**Beaver Dam Mine Project Environmental Impact Assessment
 Information Request Responses, Round 2**

Round 2 Information Request Number:	NSE-2-02
Regulatory Agency/Indigenous Community:	NSE-Lands and Forestry–Regional Services
Topic/Discipline:	Wetlands
EIS Guideline Reference:	Not listed
Revised EIS (February 28, 2019) Reference:	Not listed

FIGURE NSE-2-31-1

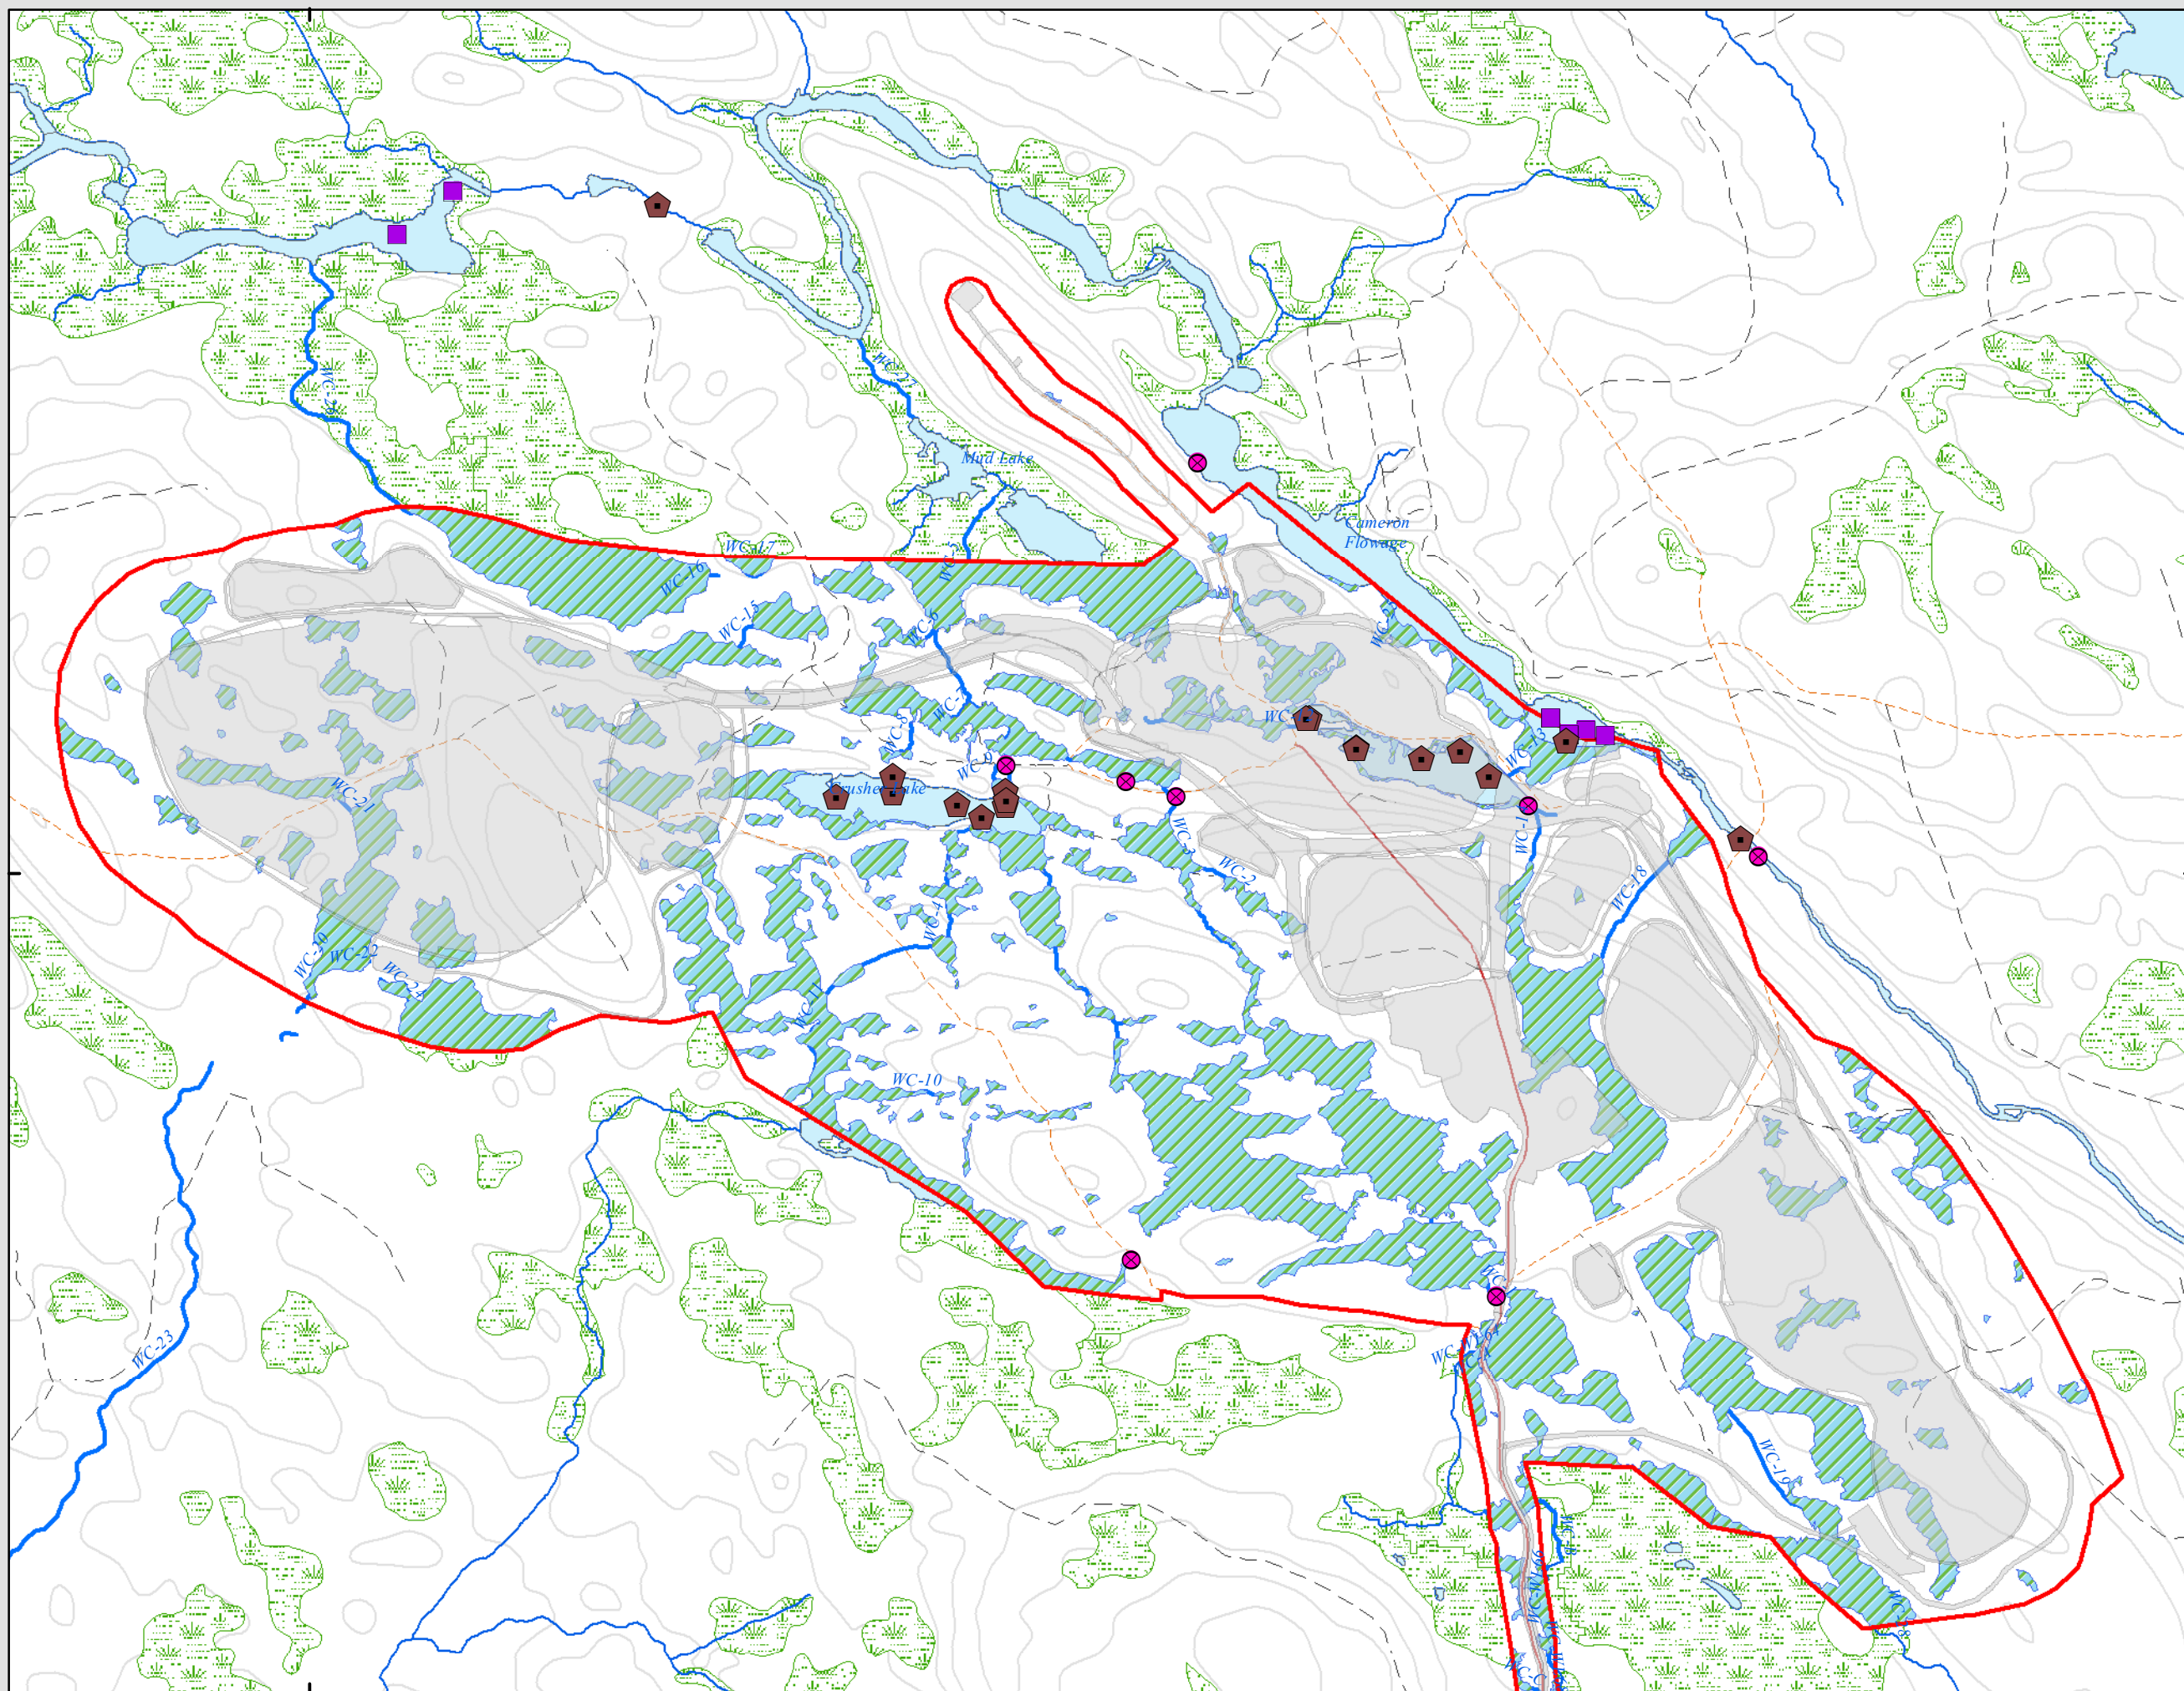
Is the figure for Appendix E.1 Figure 2-1 from the Instrinsic report (Appendix C.2)? If so, why isn't SED10 included in the Appendix E.1 data.

To address the specific, Information Request Figure 2-1 from the Intrinsic Report (Evaluation of Exposure Potential Related to Dust Deposition from Haul Road Traffic onto Soils Berries and Vegetation), Appendix C.2 of AMNS 2019 does not correspond to the locations in Appendix E.1. Table NSE 2-31-1 provides a description of the baseline sediment sampling undertaken in 2016, which were focused on an outdated Beaver Dam Mine Project Description and Mine Layout. Figure NSE 2-31-1 provides the location of the baseline sediment samples undertaken in 2016 (Referred in the legend of the figure as "Baseline Data" from Figure NSE-2-31-1). It does appear that one sample location is missing from the figure.

FIGURE NSE-2-80-1

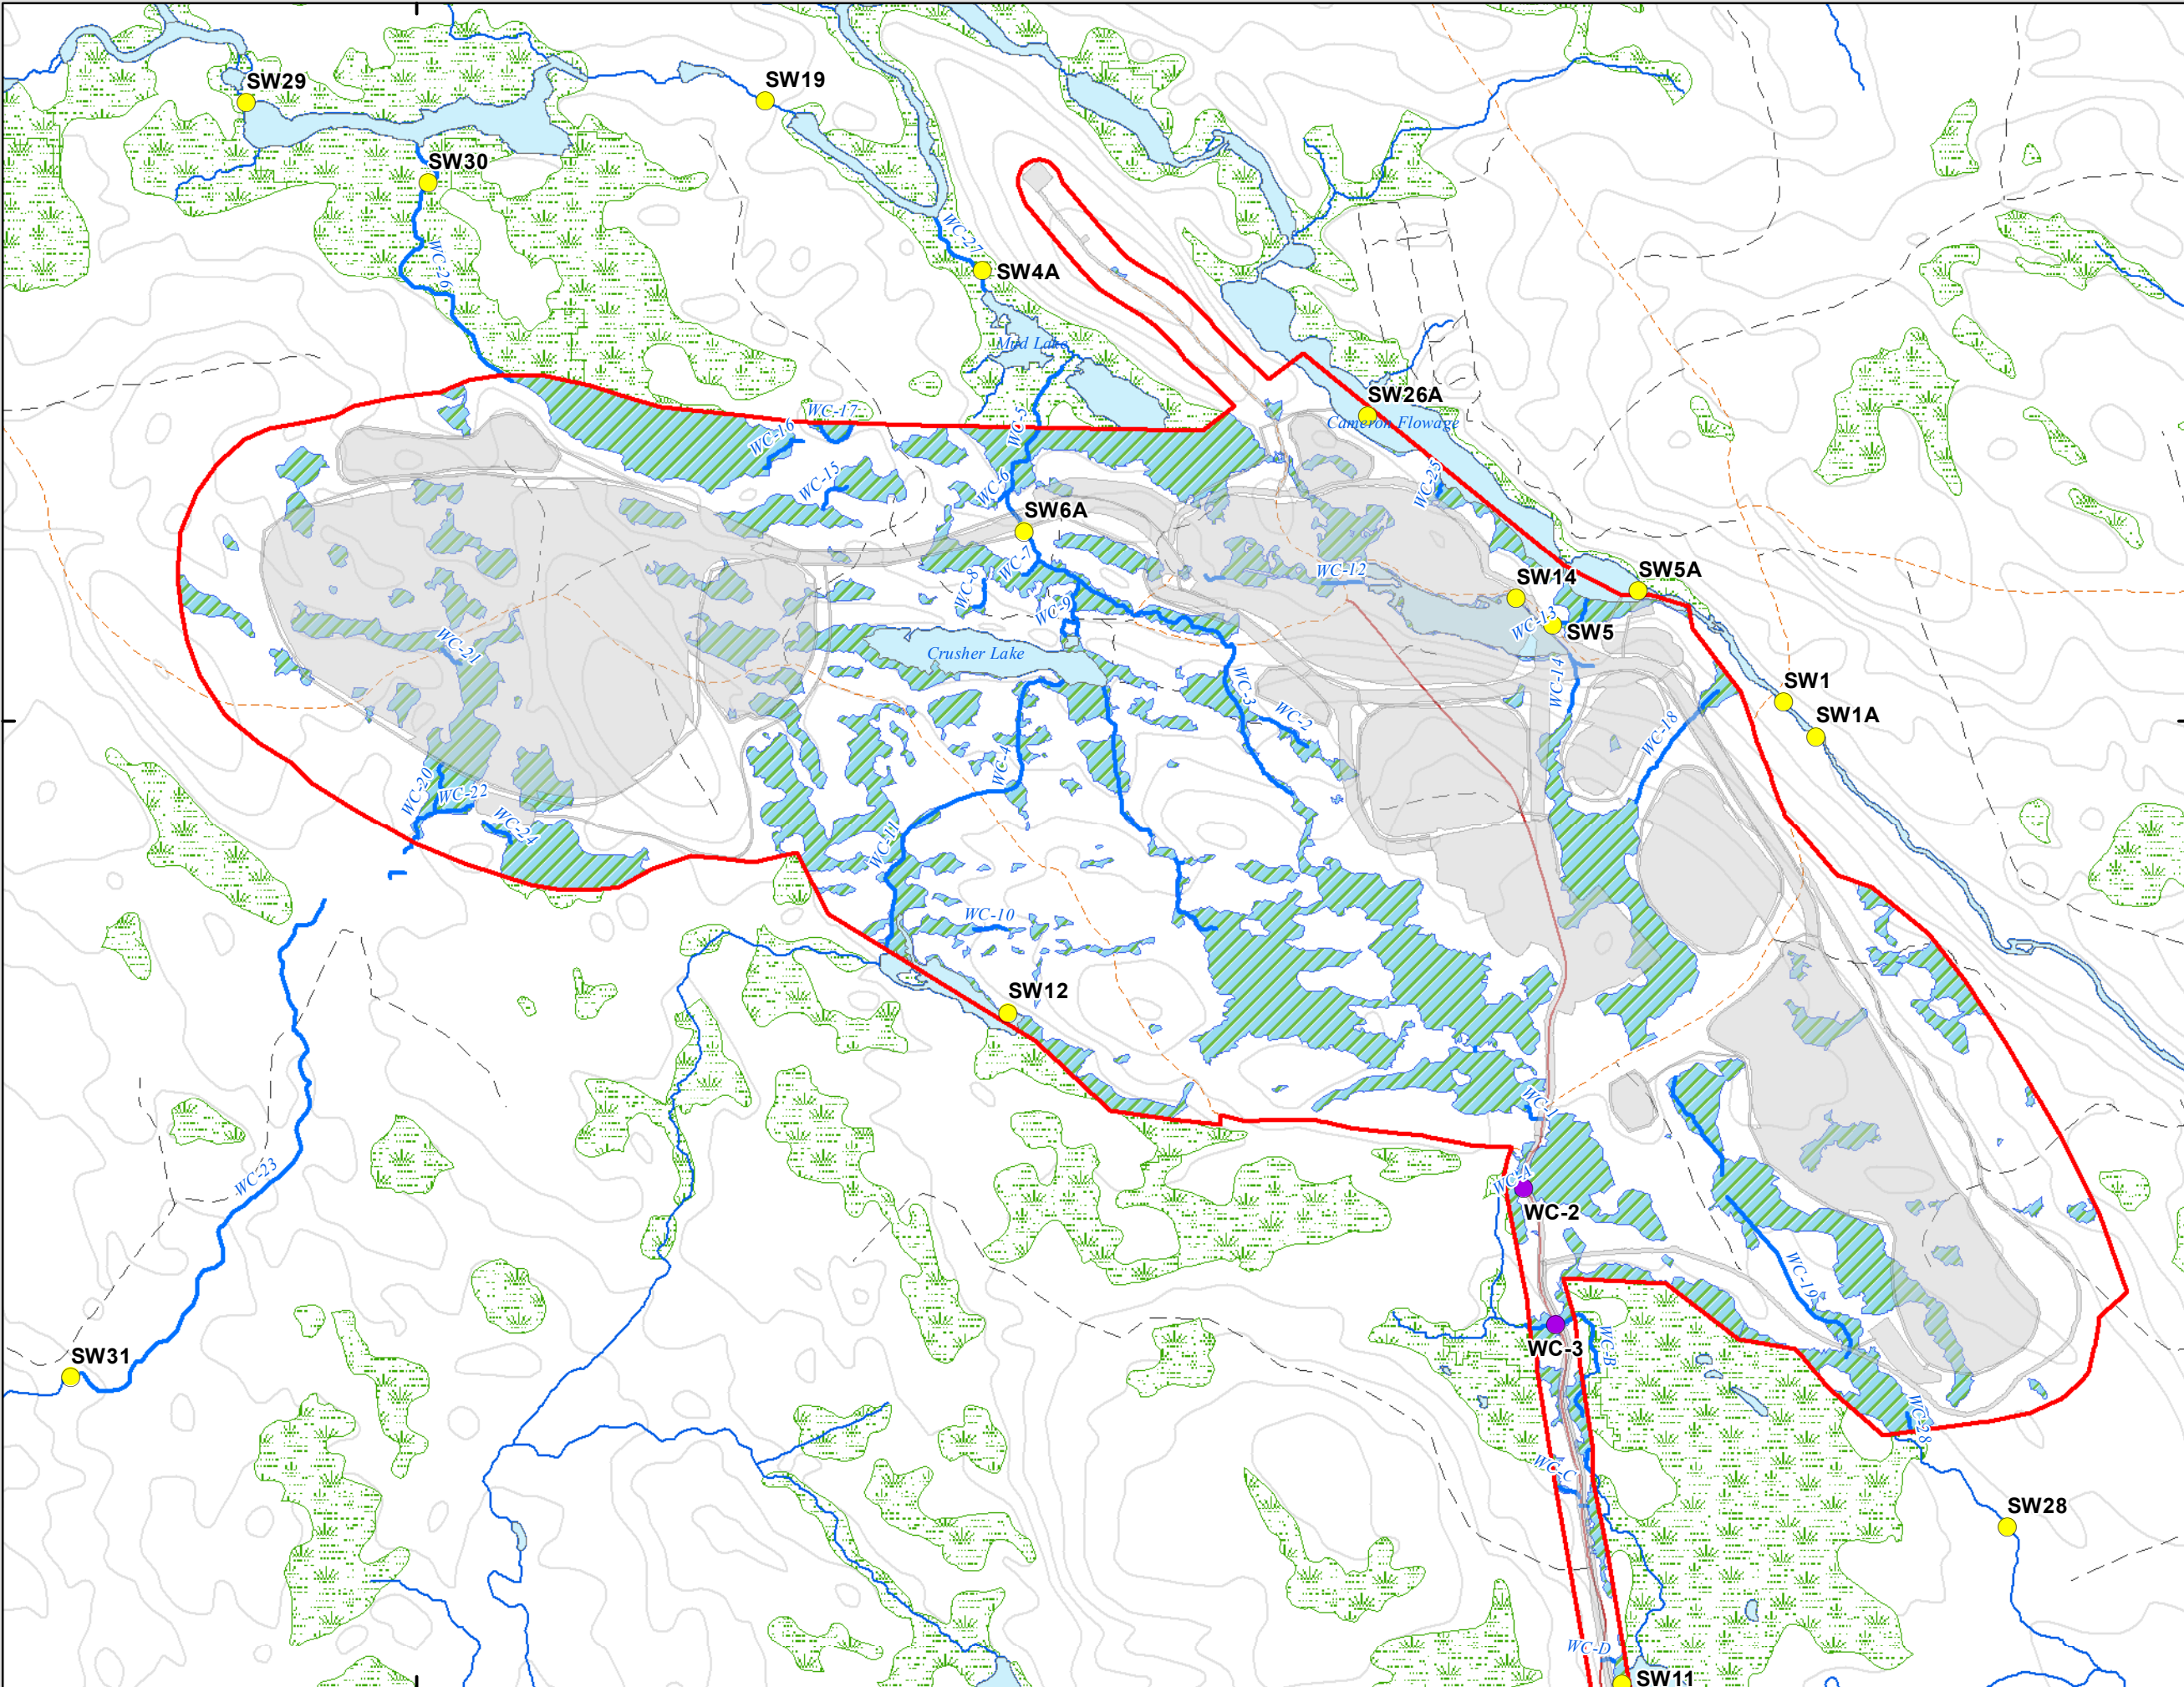
- A. There are red/orange dashed polylines on all the 6.7-3 figures without definition in the legend. They appear to be existing logging roads.
- B. There is a linear wetland that extends approximately 2/3 up the Figure 6.7-3. This appears to be a graphical anomaly and not a continuous wetland feature.

Figure 6.7-3 has been replaced and updated by Figure 6.7-1, page 6-218 and Figure 6.7-2 Series, page 6-219 to 6-222 in Section 6.7.3, page 6-217 of the Updated 2021 EIS (AMNS 2021) and have been included in IR2 response NSE-2-80 as Figures NSE 2-80-1 to NSE 2-80-2A to D. The legend has been updated to show the red/orange dashed polyline as a Seasonal Road. The linear wetland referred to as a graphical anomaly was removed as it was discovered to be an error in the map.

Figure NSE-2-141-1: Estimated In-Pit PAG Solids (purple)

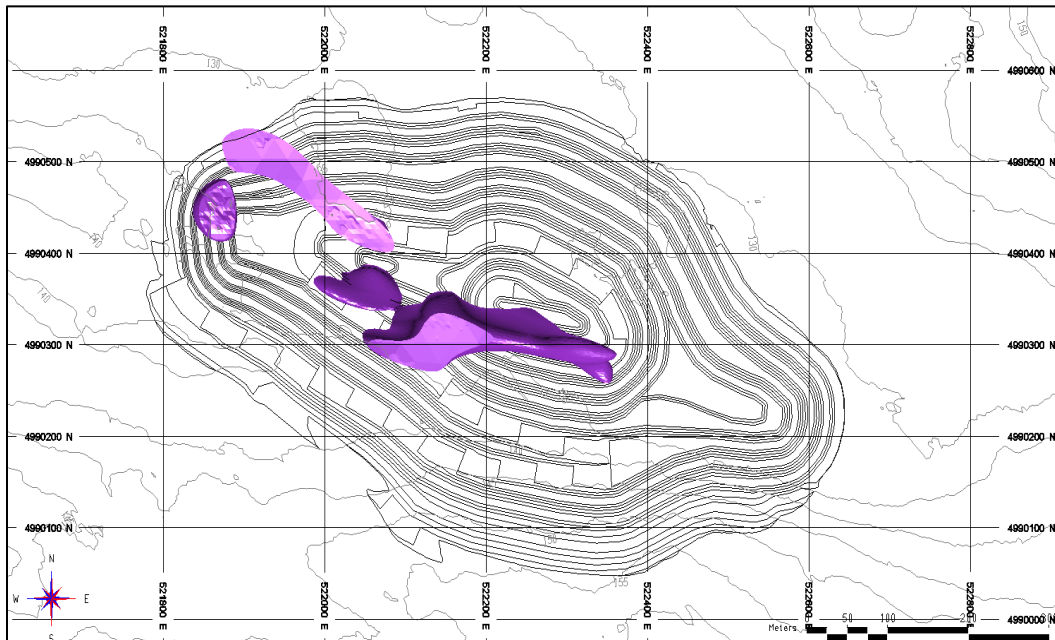
This section reports the results from ML/ARD assessment. The only indication of the locations of samples is a map in Figure 3-1 in Appendix E-2. No cross sections are provided and so it is not possible to assess the distribution of samples throughout the proposed mine pit and the range of rock which will be encountered. Also it is not clear which of the samples are being assessed for kinetic testing represent ore (which will ultimately be disposed to the Touquoy pit) and what portion represent waste rock (which will remain at BD). As per the MEND Prediction Manual for Drainage Chemistry from Sulphidic Geological Materials (Page 8-5), geological cross sections should be provided showing the locations of the samples in three dimensions within the proposed mine pit, particularly for the kinetic.

Please see Figure NSE-2-144-1 for estimated in-pit potential acid generating (PAG) solids.
